## Discussion of “Observed Performance of Long Steel H-Piles Jacked into Sandy Soils” by J. Yang, L. G. Tham, P. K. K. Lee, and F. Yu

January 2006, Vol. 132, No. 1, pp. 24–35.

Bengt H. Fellenius<sup>1</sup>

## Closure to “Observed Performance of Long Steel H-piles Jacked into Sandy Soils” by J. Yang, L. G. Tham, P. K. K. Lee, and F. Yu

Fig. 1. Authors' load distribution showed in Fig. 12 converted from pile stress to pile load and approximated (solid lines) in an effective stress analysis employing the Beta-coefficients shown

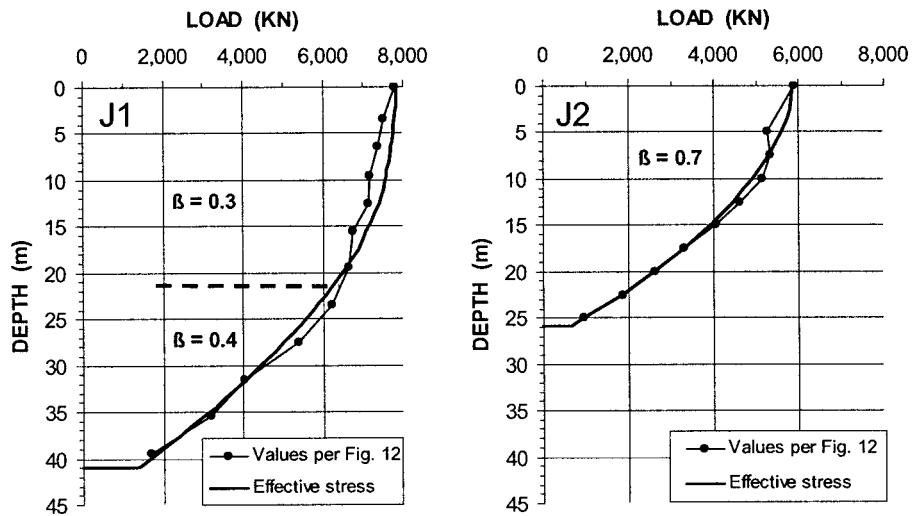
The authors determined the distributions of unit shaft resistance shown in Fig. 13 by differentiation of the load from one strain gauge to the next. Such differentiations will invariably enlarge data imprecisions. For example, if the load difference between two gauge locations is 8% of the load value and the imprecision (error) in each load value is about  $\pm 4\%$  of the load, then the potential imprecision in the evaluated unit shaft resistance determined by differentiation between the two gauges will range from zero unit shaft resistance through a unit shaft resistance of twice the correct shaft resistance value for a case where the loads are infinitely precise. The discussor believes the scattered distributions of unit shaft resistance illustrated in Fig. 13 is not due to variation of the actual shaft resistance, but to imprecisions of the strain measurements (and their conversion to load) in the piles. A more realistic distribution of the unit shaft resistance can be obtained by approximating the load distributions of Fig. 12 in an effective stress analysis and determining the unit shaft resistance from that approximation. The discussor's assumptions are hydrostatic pore pressure distribution, shear forces developing on the surface of the “H” rather than on the “square,” and that the authors' distributions do account for all locked-in loads—the pile toe depth is as scaled from the authors' figure. The discussor's Fig. 1 shows the so-approximated load distributions and the data of Fig. 12 (after conversion from pile stress to pile load using the nominal steel area of the H-piles). The distributions shown are those for the maximum loads applied in the static loading tests on the two piles, 7,788 and 5,900 KN, respectively.

The load distribution approximations correspond to a distribution of unit shaft resistance plotted in Fig. 2 together with the

Fig. 2. Distribution of unit shaft resistance from the effective stress analysis (solid lines) and the distributions presented in the authors' Fig. 13

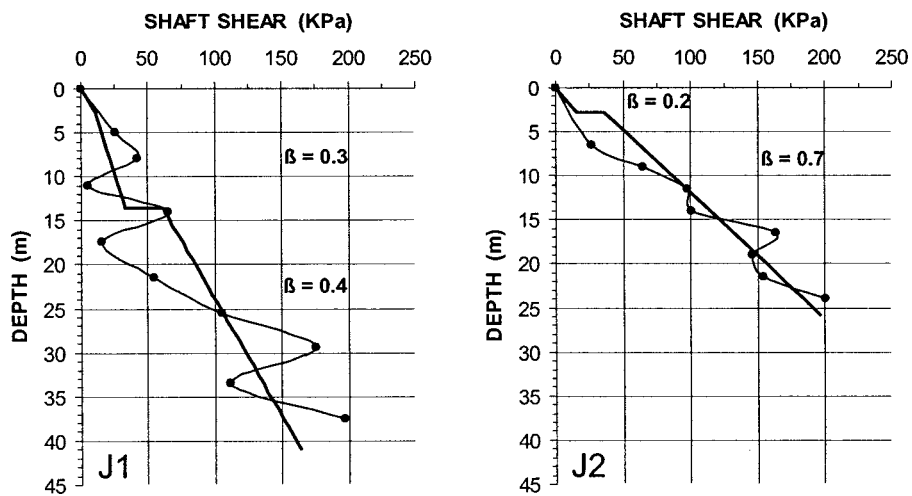
distributions of Fig. 13. The unit shaft resistance values determined from the approximated measured load distributions imply that the scatter shown in Fig. 13 is not representative for the site conditions. Note that the measured pile toe loads (stress) during the jacking of the piles shown in Fig. 7 indicate almost linear increase with depth, which supports the contention that effective stress governs the load and resistance distributions at the two sites. It also supports that the varying distributions of unit shaft resistance shown in Fig. 13 are not representative for the actual conditions at the two sites.

Moreover, the analysis demonstrates that the two sites show

distinctly different magnitudes of shaft resistance (as do also the original figures, albeit this is disguised by the authors' use of different depth scales in Fig. 13). It would be of interest if the authors could expand on the potential cause of the difference between the two sites.

The toe resistances determined by fitting the data to the effective stress analysis correspond to a toe bearing coefficient,  $N_t$ , of 100 when calculated on the actual steel cross section area, and to  $N_t$ , equal to 30 if calculated over the area of the circumferential square. Neither value conflicts with the reported SPT N-indices shown in Fig. 1.

able to provide “a more realistic” distribution of shaft resistance. The discussor’s method assumes that the distribution of shaft resistance is perfectly linear with a constant  $\beta$  value, which should be an idealized rather than a real case, as natural deposits are never perfectly uniform. Fitting of the pile-load curve using a smooth curve will simply remove the clue for the recorded real-life variations, which might be due to other reasons such as the existence of thin soft layers that were not discovered by soil borings at the site or due to the existence of a gap between the pile and surrounding soil caused by pile installation.

11. Possible reasons for the observed difference in shaft resistance between Piles PJ1 and PJ2 have been mentioned in the original paper. One of the reasons is the differences of ground conditions at the two sites. The second is probably related to the different treatments of the gap between the pile and surrounding soil generated during pile installation. The third reason may come from the difference of the termination criteria adopted for jacking of the two piles. A more detailed discussion of the effect of termination criteria on the behavior of jacked piles has been given by Yang et al. (2006).

Fig. 1. Grading curves of decomposed granite soil in Hong Kong (after Lumb 1962)

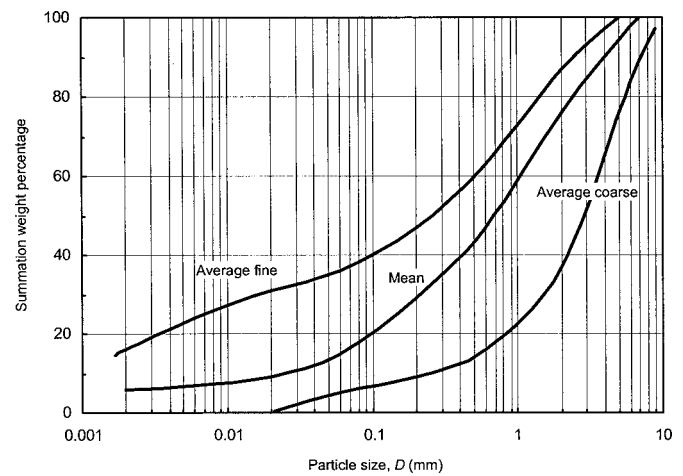
2. The description of the saprolite is very brief; however, Saprolite is a rather unusual soil, outside Hong Kong, that is. Yet, the authors make comparison references to papers reporting results from pile test in other soil types of similar grain size but having different genesis and mineralogy. Would the authors be able to expand on the particulars of the saprolite? Perhaps add the results of a CPTU sounding from the vicinity of the site?

1. Both sites are located on reclaimed land whose water-table conditions are generally different from those of the natural sloping terrain. It is considered acceptable to assume that the soil profile below the water table at the sites is saturated and the pore-water pressure distributes hydrostatically.
2. The decomposed granite is a residual soil formed by weathering of the parent rock. This type of soil exists widely in Hong Kong and other areas of the world, such as Japan and Malaysia. Typical particle-grading curves of the decomposed granite soil in Hong Kong are shown in Fig. 1, which were established by Lumb (1962) using 72 samples. The soil is essentially sandy and relatively permeable. Details on various properties of the soil can be found in the works of Lumb

(1962; 1965). Because of the nature of the soil, cone penetration tests (CPT) are rarely used in ground investigation. The standard penetration tests (SPT) are dominant in local practice.
